Agenda Item # 8

BOA-003137-2024

4450 Old Shell Road

REQUEST Sidewalk Width, Vehicular Parking Access Width, and Street Tree Spacing Variances

SITE PLAN

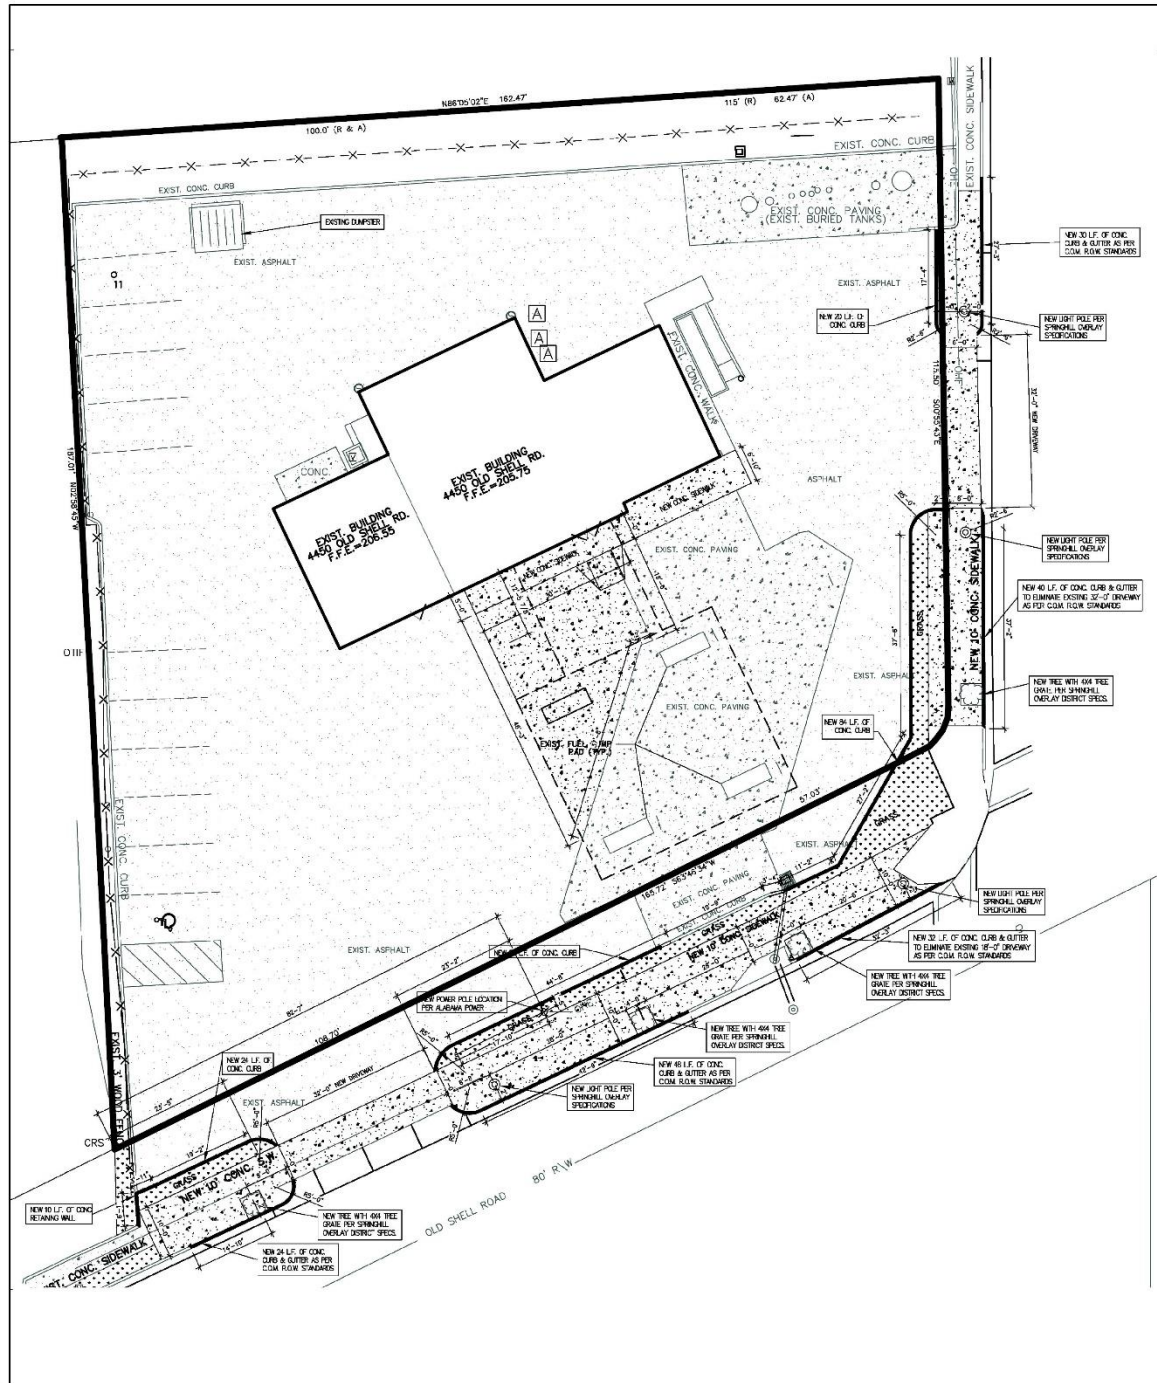
The proposed site plan submitted by the applicant depicts 10-foot wide sidewalks along the majority of the property frontage, with the exception of a portion along McGregor Avenue, adjacent to the underground storage tanks, where the sidewalk is proposed to remain in its existing configuration of approximately four (4)-feet wide. Chapter 64, Article 13-4.B.3.(e)(1) of the UDC requires sidewalks in the Spring Hill Overlay District to be a minimum of twelve (12)-feet wide.

The subject site has three (3) existing curb cuts to Old Shell Road, and two (2) existing curb cuts to McGregor Avenue. The proposed site plan shows all but one (1) curb cut to each street frontage being removed from the site, and the remaining curb cuts to be 32-feet wide each. Chapter 64, Article 13-6.F.2. of the UDC requires curb cuts to be a minimum of 24-feet wide, and a maximum of 30-feet wide.

Chapter 64, Article 13-5.D.6. of the UDC requires street trees to be planted approximately 30-feet on center. The proposed site plan depicts a total of four (4) street trees. The proposed trees are spaced approximately 76-feet, 27-feet, and 51-feet apart. If the trees were spaced closer together, as required, additional trees could be placed on the subject site.
